Beck Park Expansion – Phase 1

Bid # 25-11

ADDENDUM No. 4

April 17, 2025

sheet number
C3.01

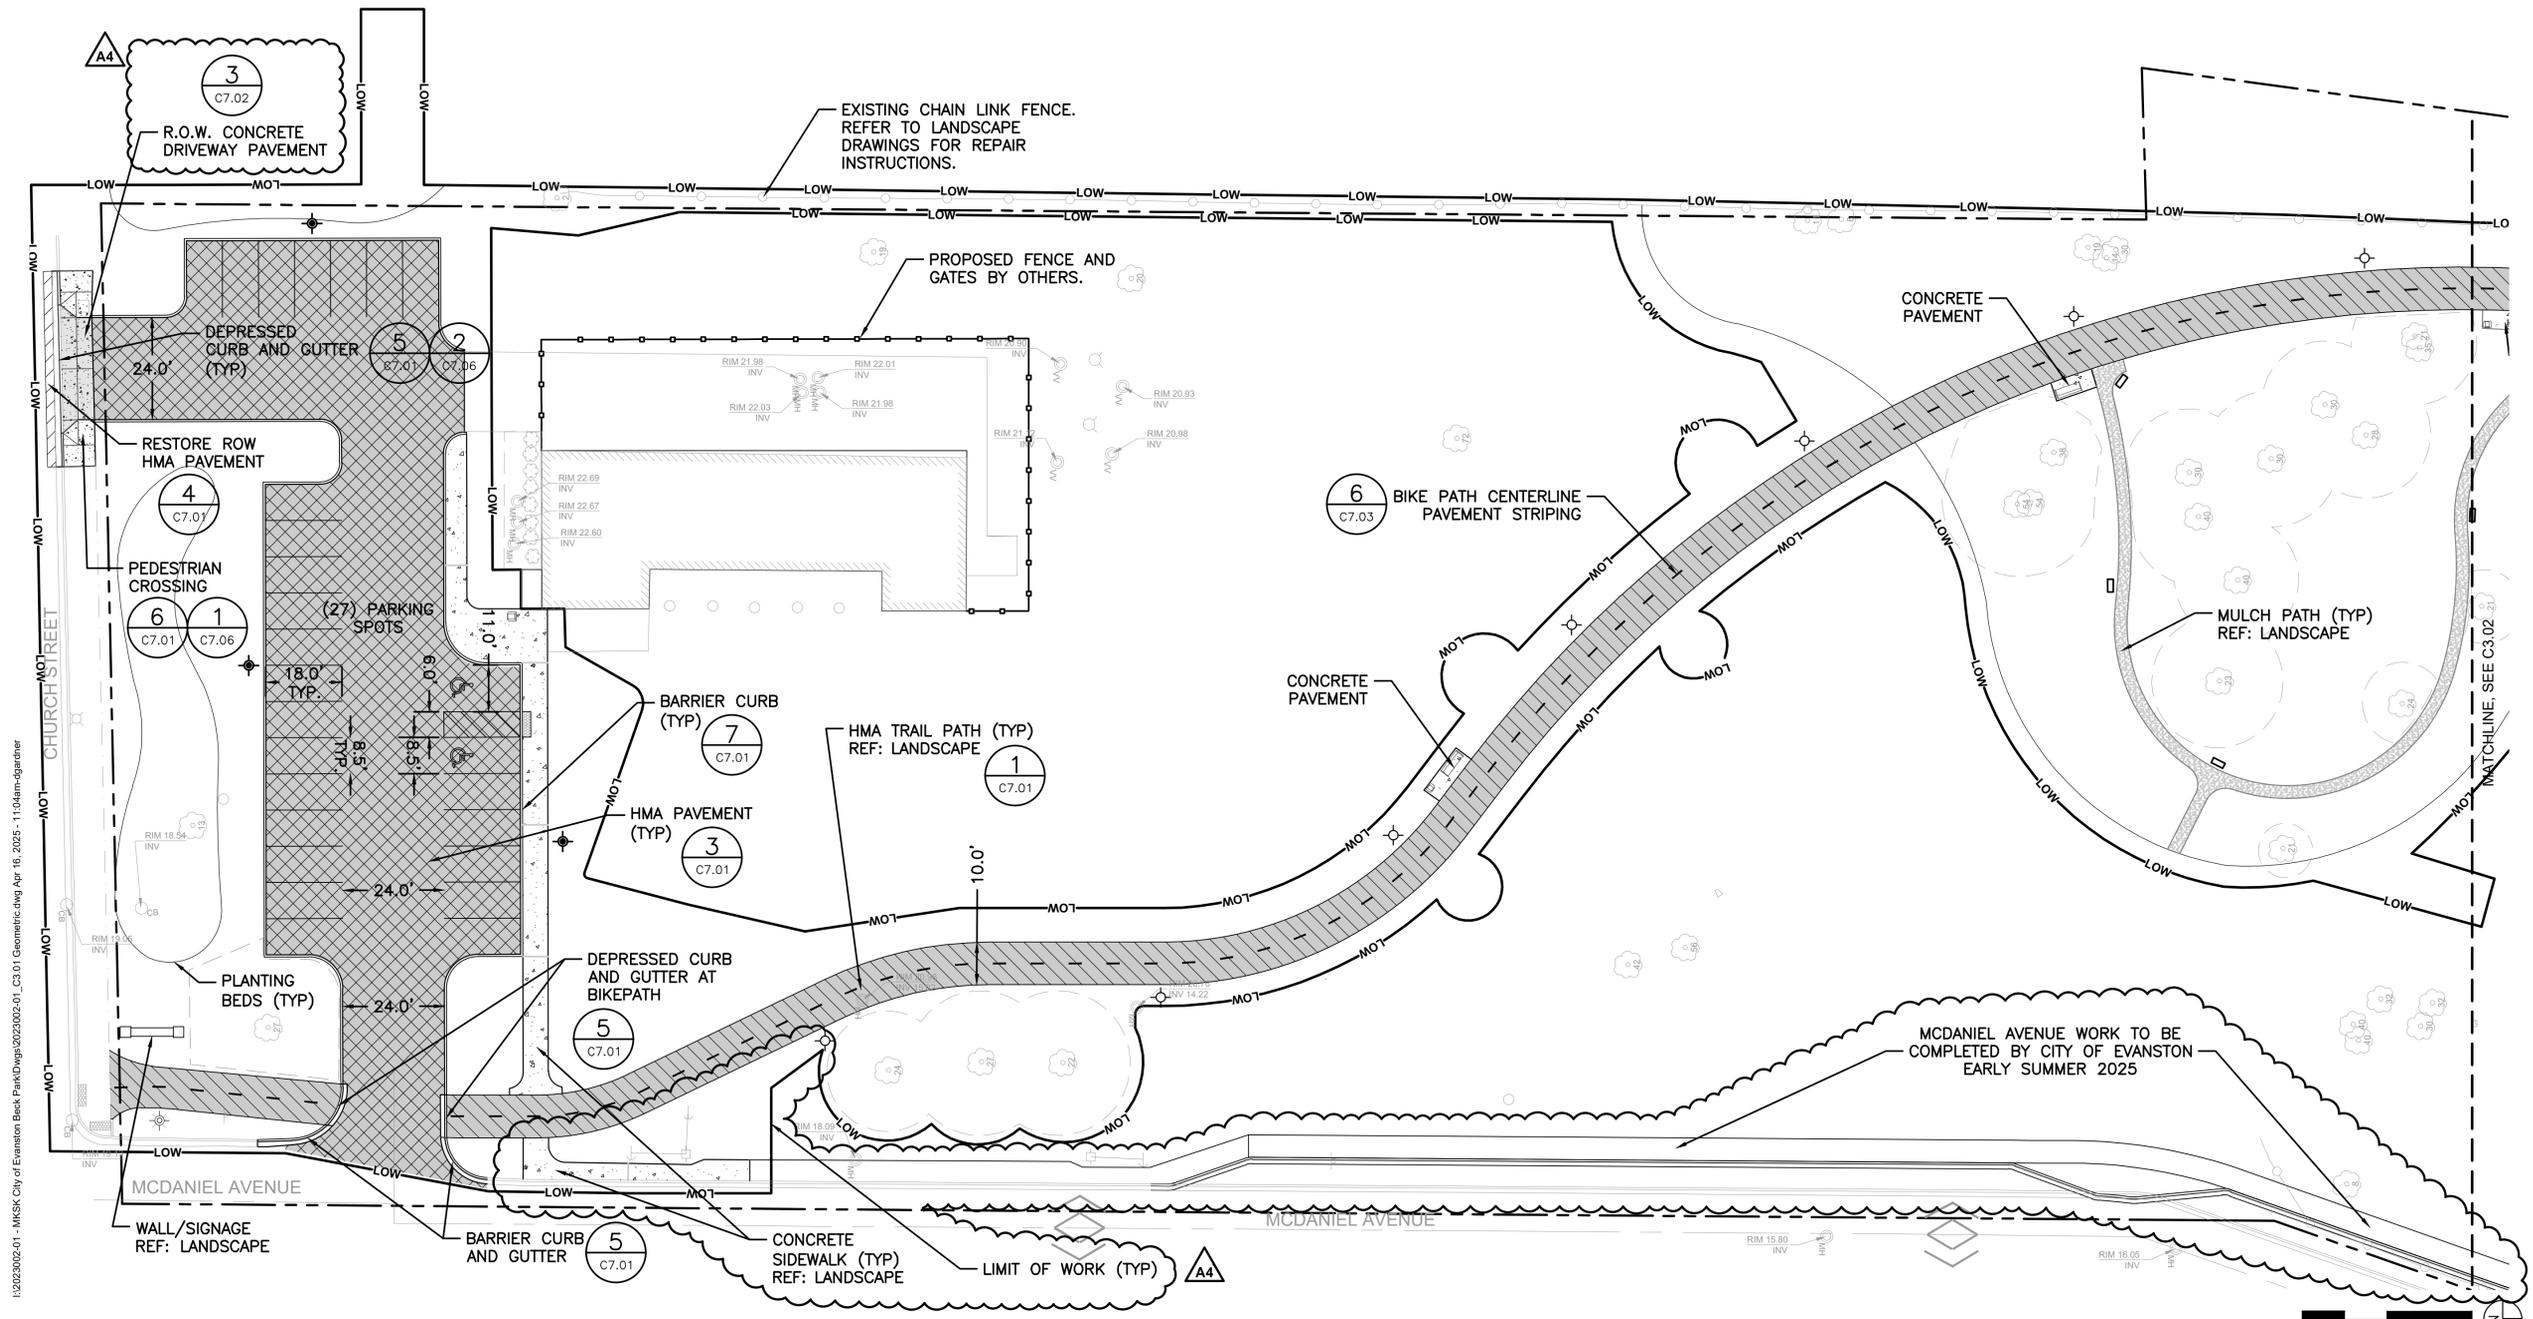
- Sidewalk connection to McDaniel Avenue Street Project added
- McDaniel Avenue Street Project (By City of Evanston) added, for reference
- Added new callout/detail reference for R.O.W. concrete driveway pavement at southwest parking lot driveway.

sheet number
C3.02

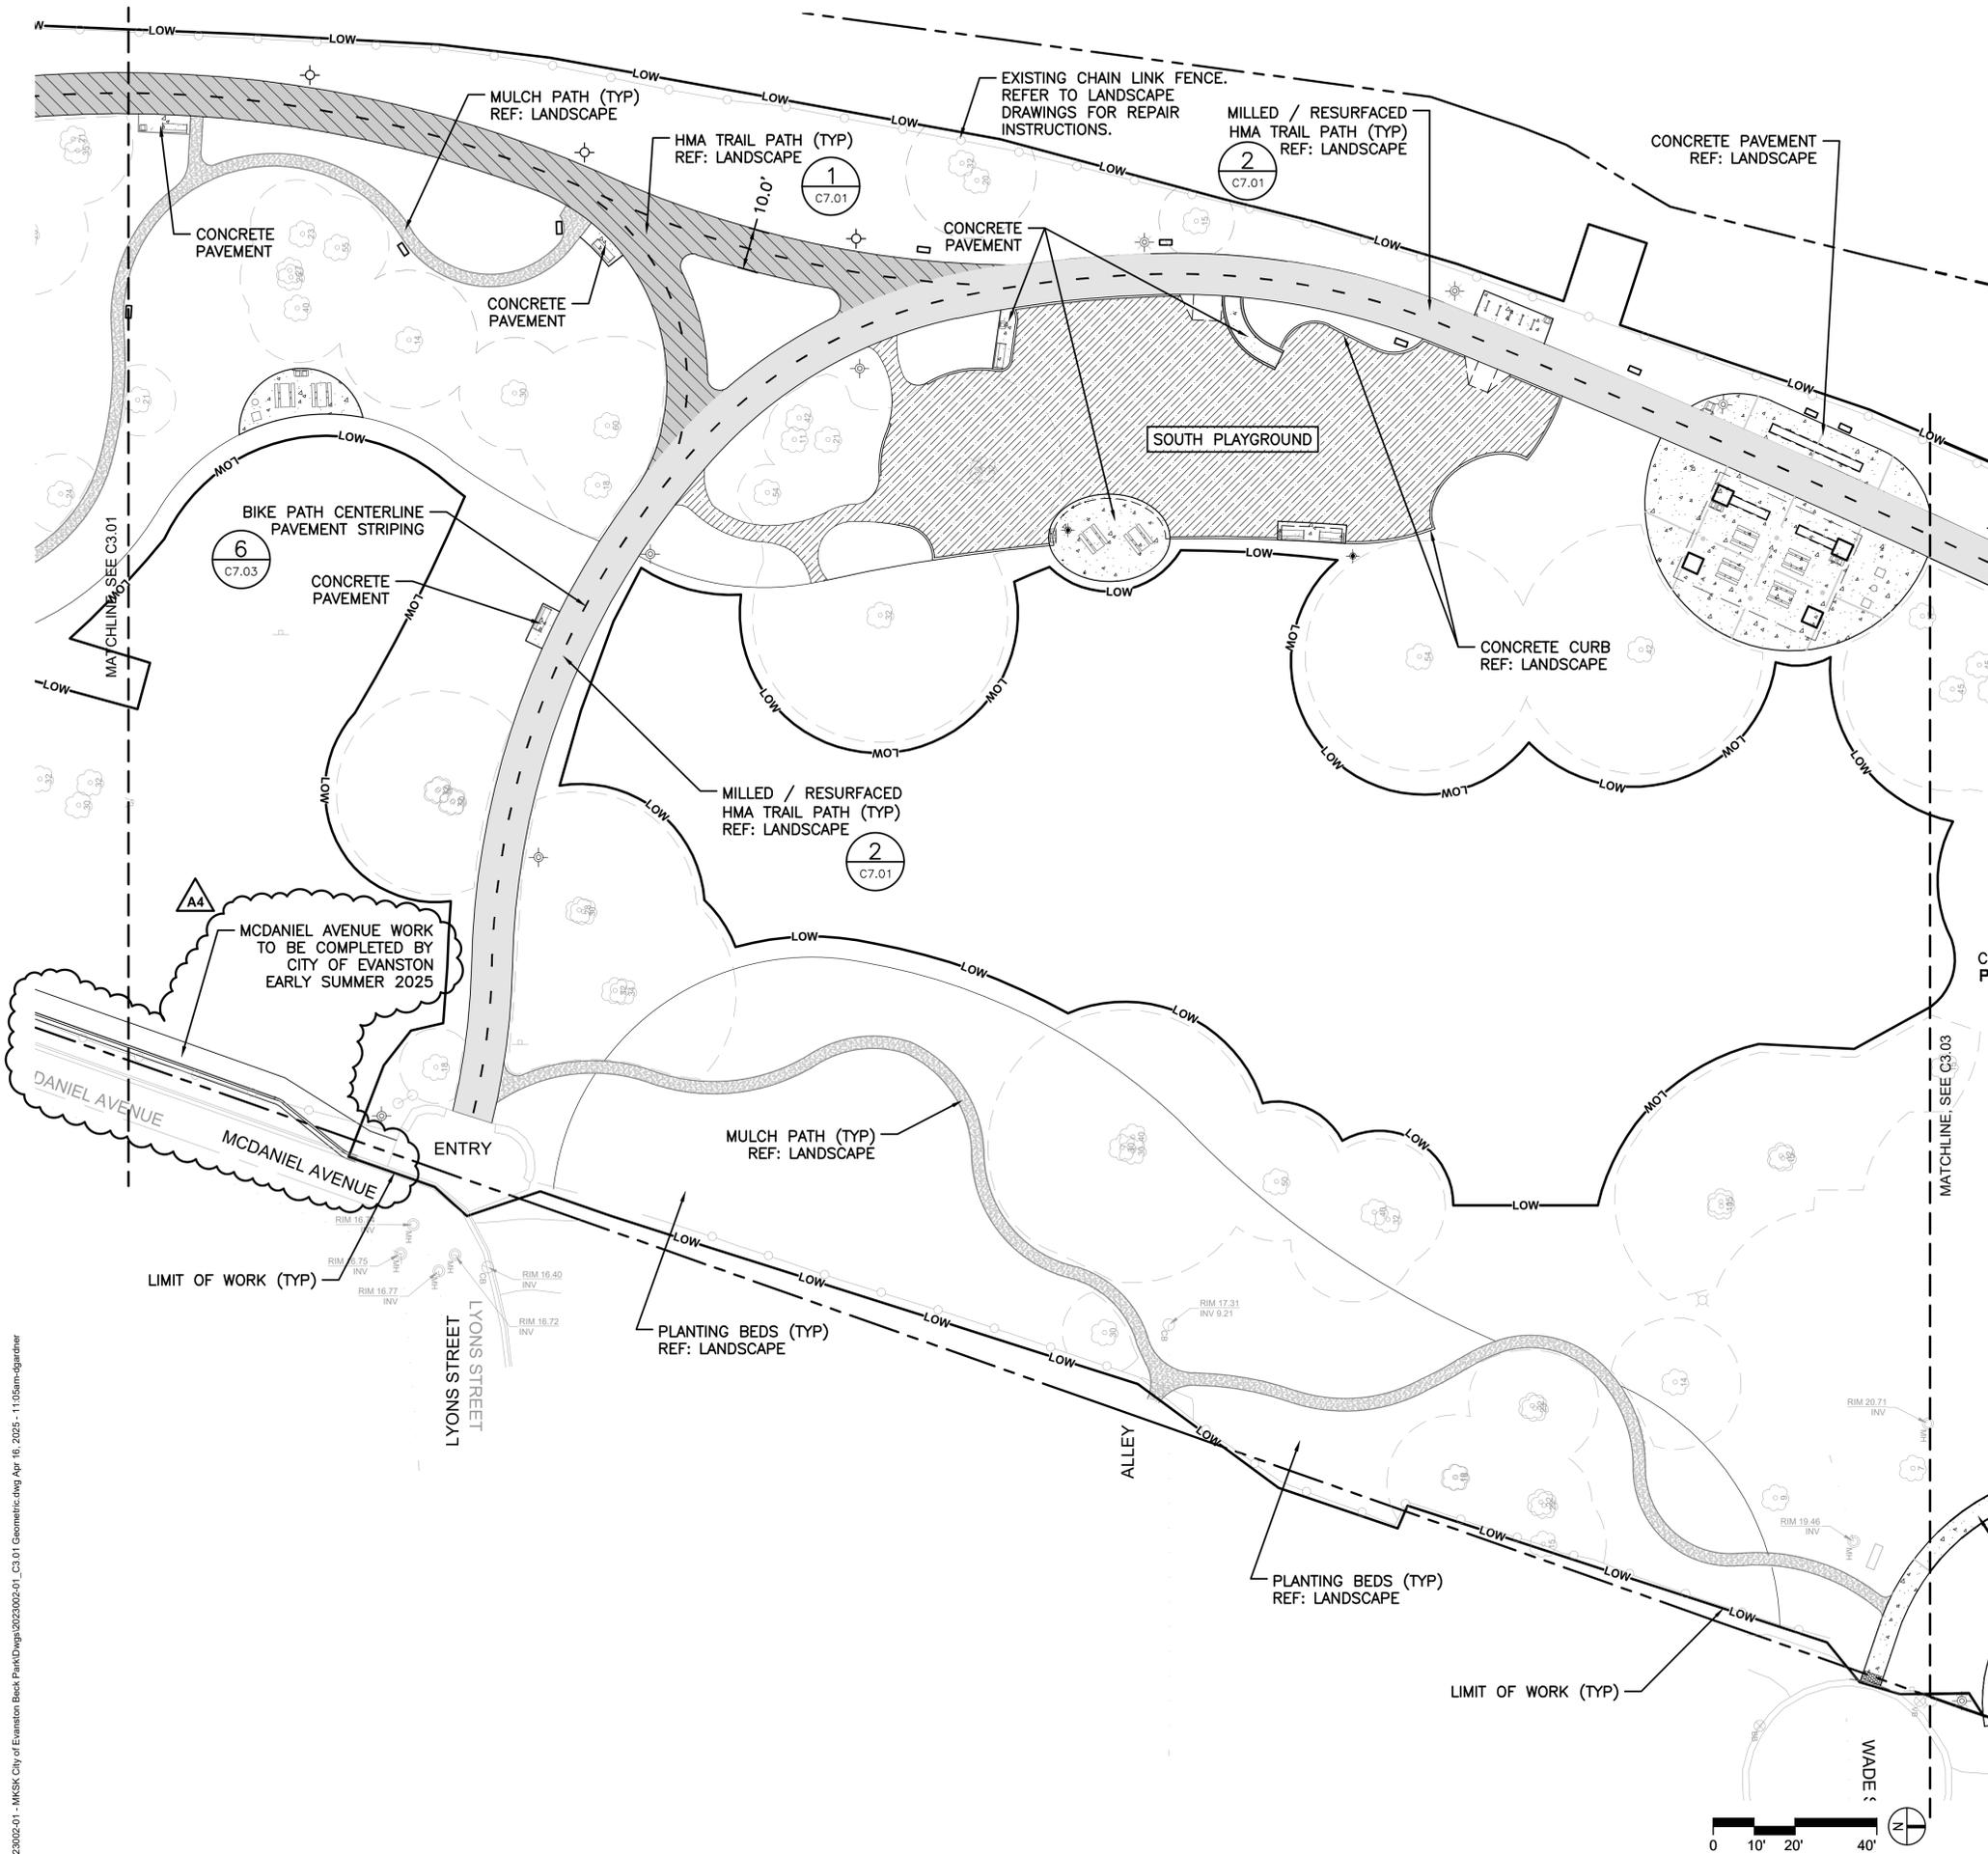
- McDaniel Avenue Street Project (By City of Evanston) added, for reference

sheet number
C5.01

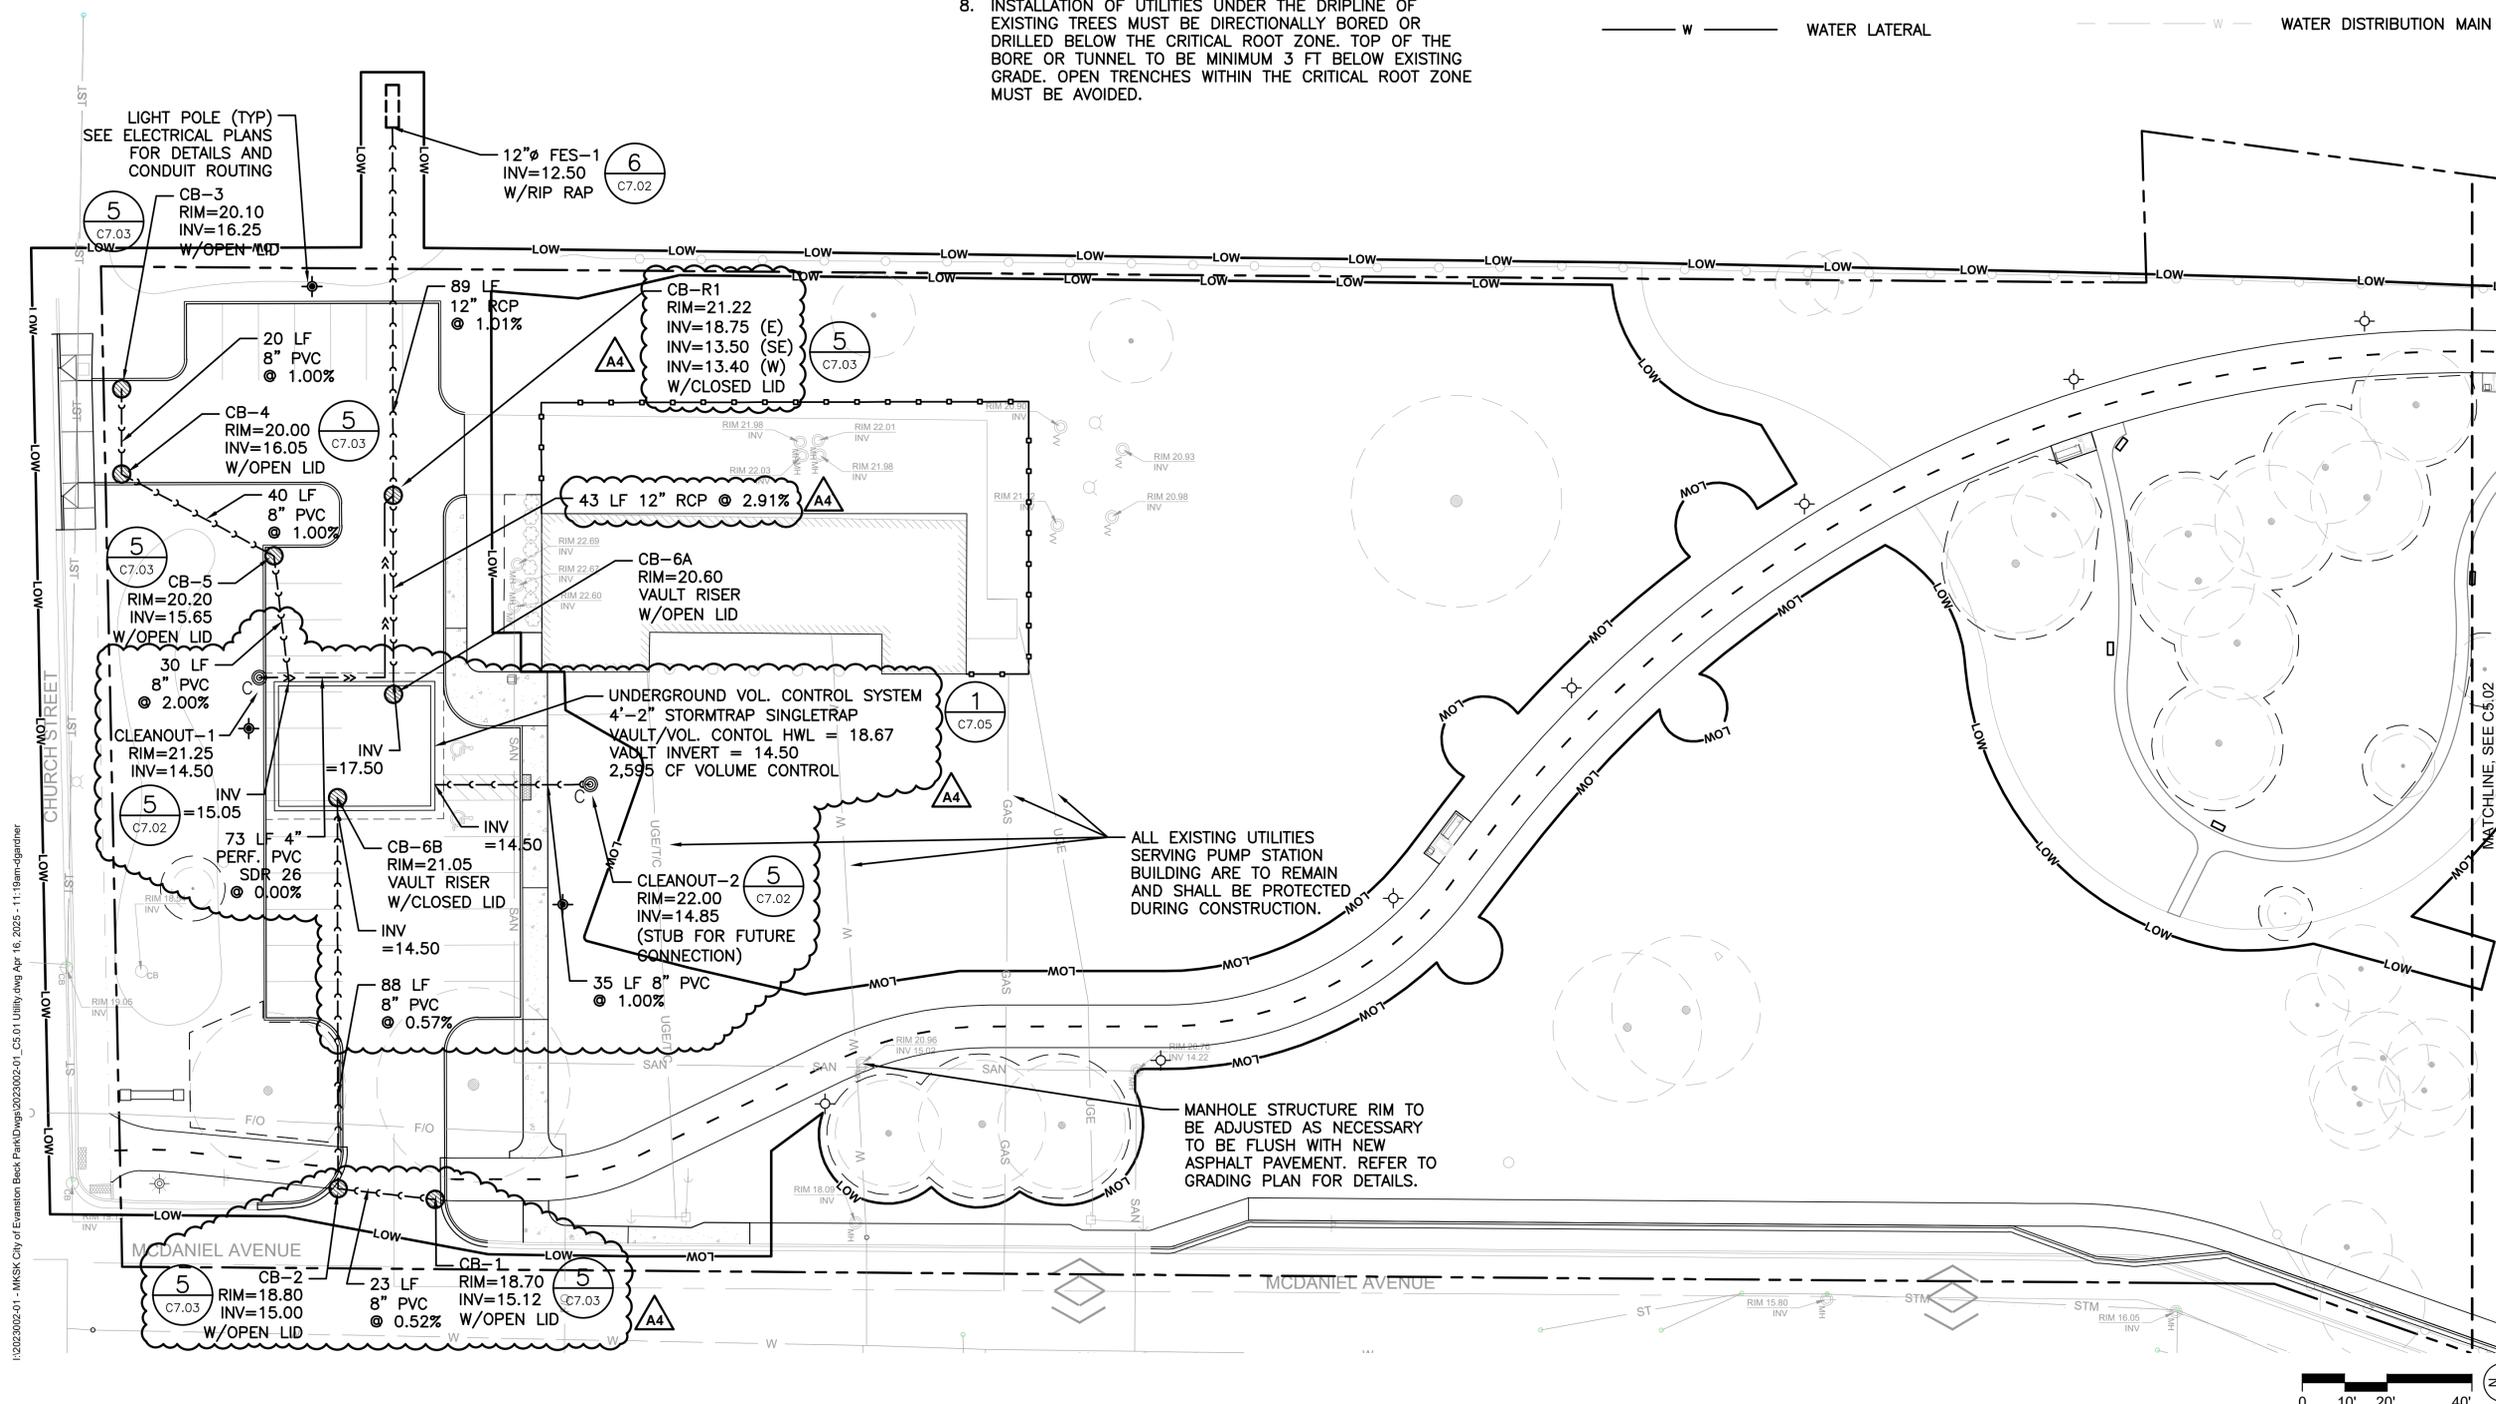
- Reduced size of underground StormTrap vault
- Raised elevation of underground StormTrap vault by 12"
- Adjusted adjacent storm sewers accordingly.
- Replaced outlet control structure (including custom vortex restrictor) with standard catch basin.
